# Gateway Estates Unit One Replat H

City of El Paso — City Plan Commission — 10/4/2018

**SUSU18-00063 — Resubdivision Preliminary**

### **Cherrington Street**

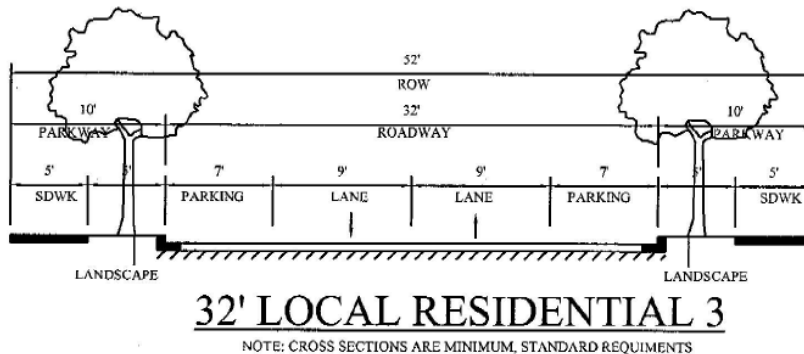
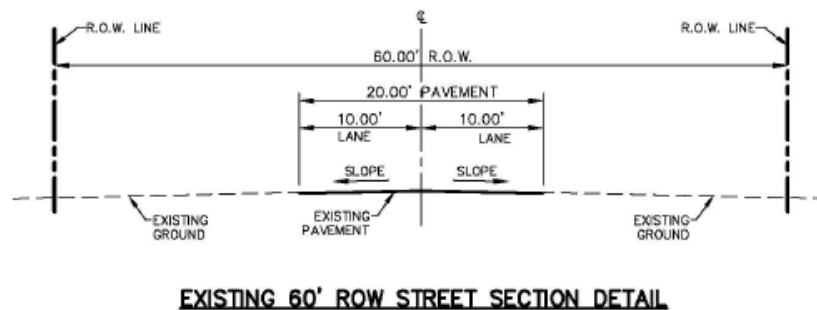
The applicant's proportionate share, per the DSC, would require installation of six additional feet of pavement, a 5' landscape parkway and 5' sidewalk.

The ROW width exceeds the requirement, however, no improvements are proposed.

The proposed exception does not meet the following criteria under Section 19.10.050.A.1.c. (Roadway participation policies – Improvement of roads and utilities within and or abutting the subdivision) for requesting an exception as written concurrence from the County of El Paso has not been received for the waiver of improvements for the above mentioned street. The section reads as follows:

## **ATTACHMENT 2**

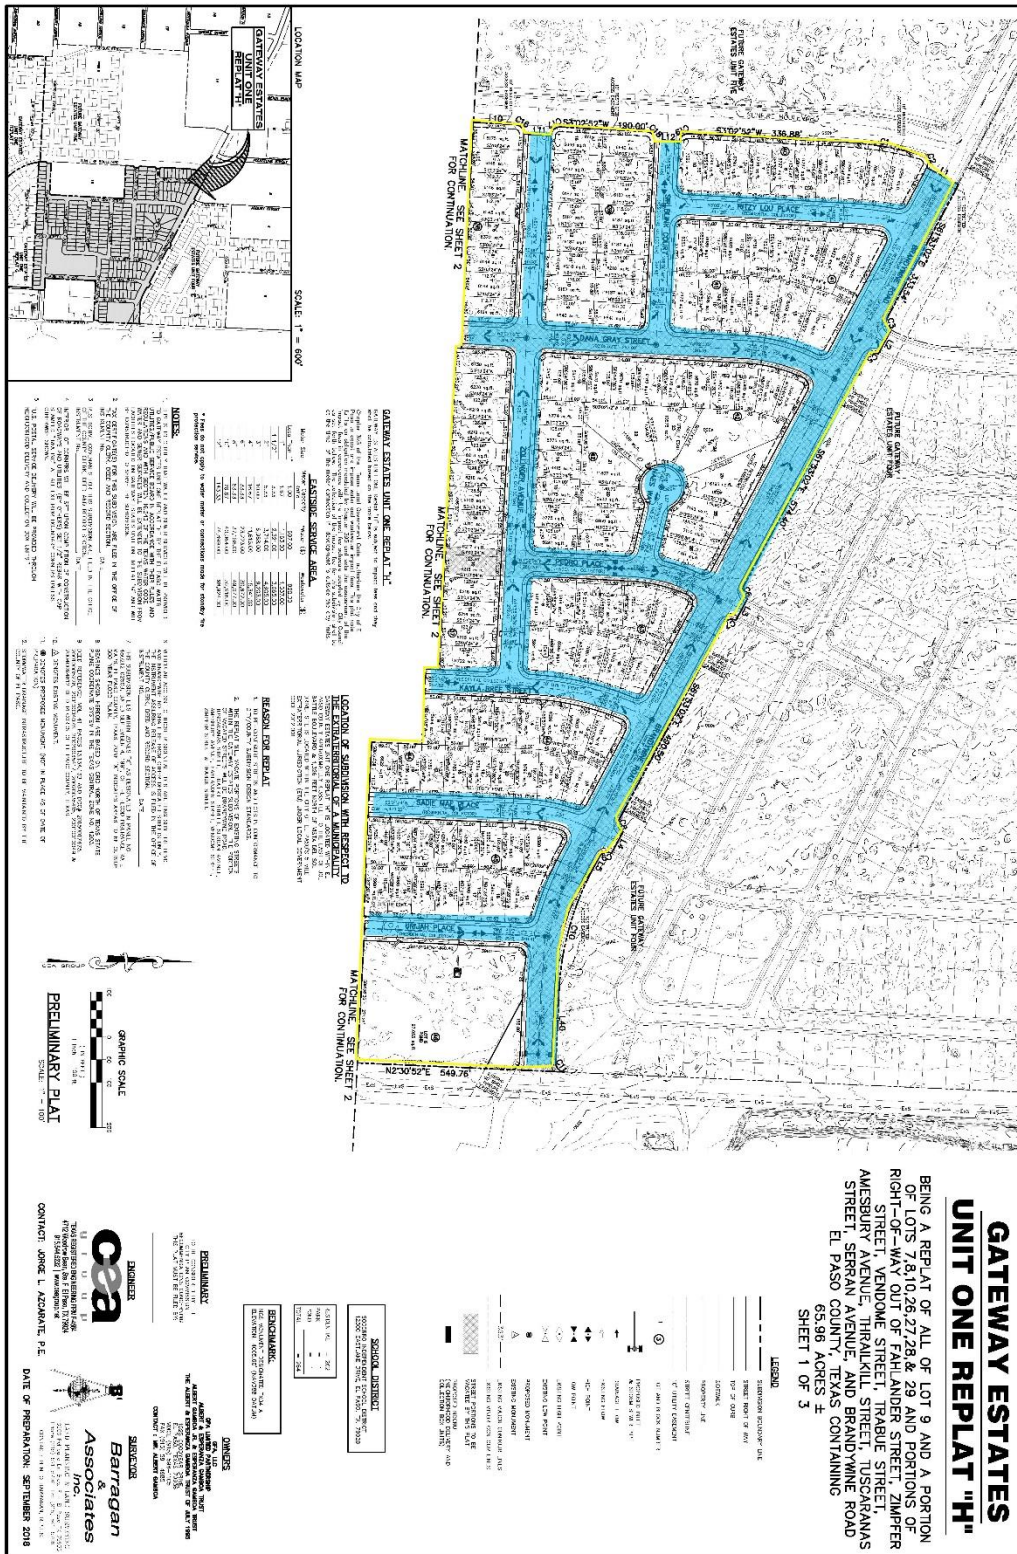
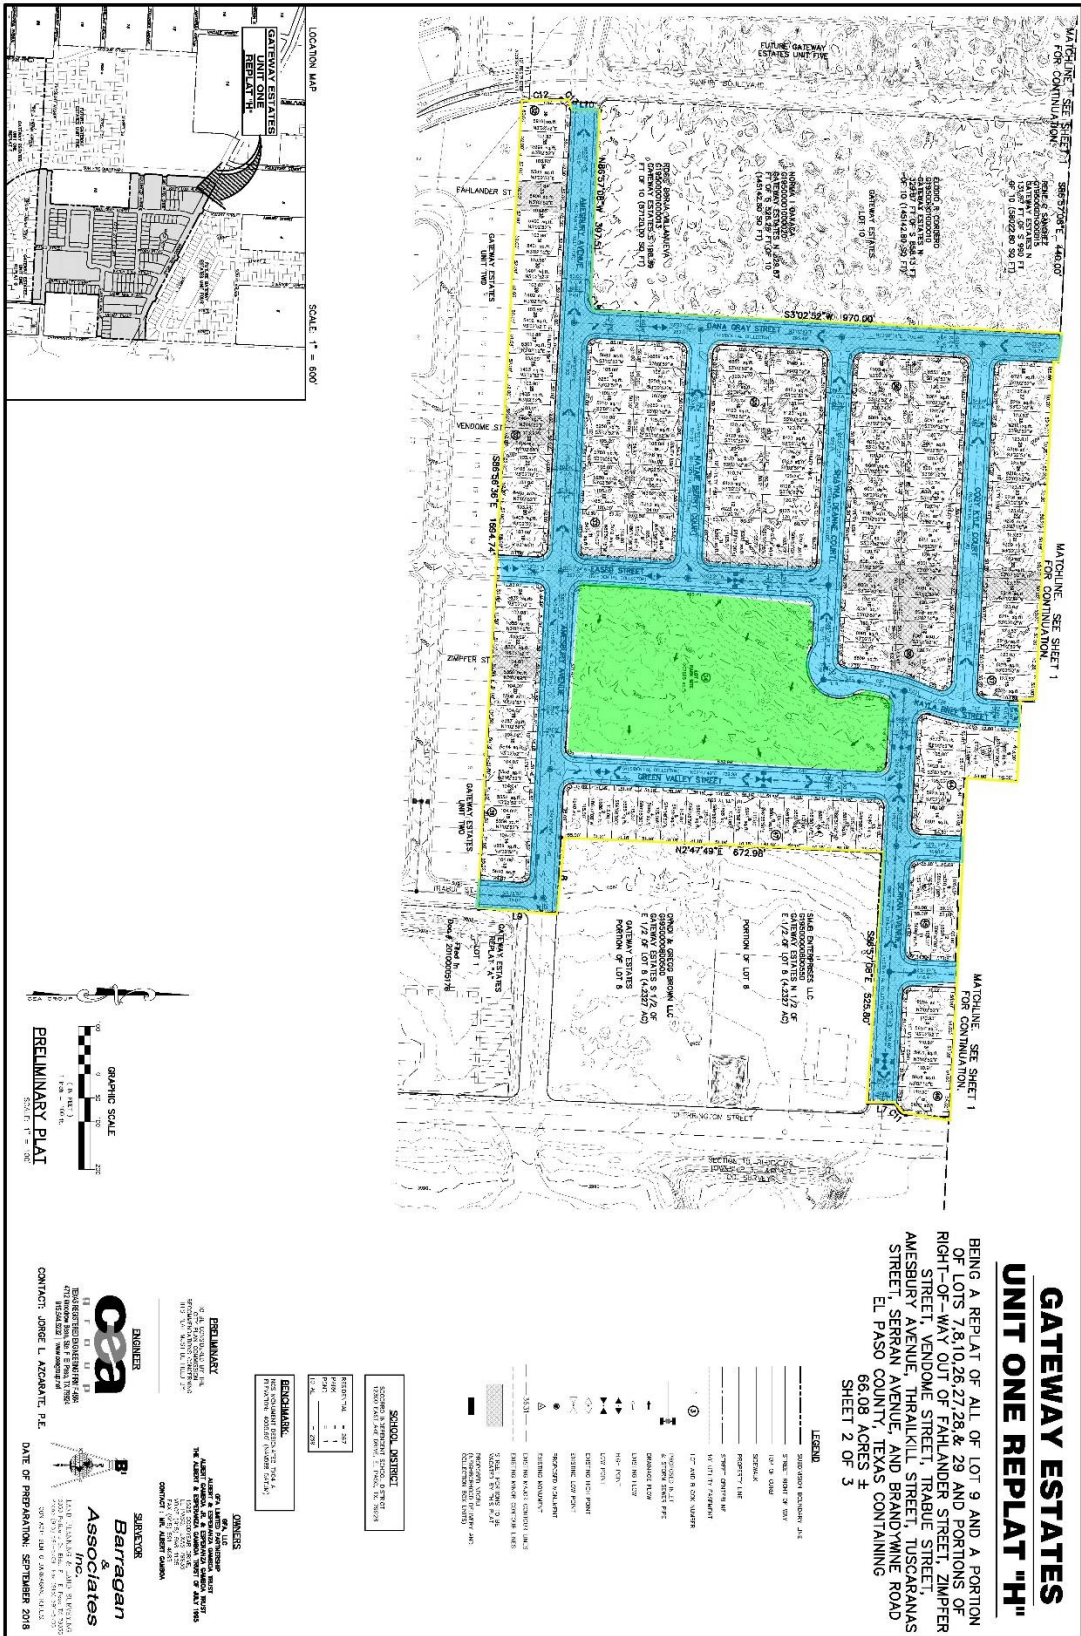
1. The proposed pond shall have enough capacity to hold the developed runoff based on the old requirements.
2. On the legal description, add the county and state.

Change Block 33 to 37

Change Block 34 to 38

Change Block 35 to 39

Change Block 36 to 40

Change Block 37 to 41

Change Block 38 to 42

Change Block 39 to 43

Change Block 40 to 44

Change Block 41 to 45

Change Block 42 to 46
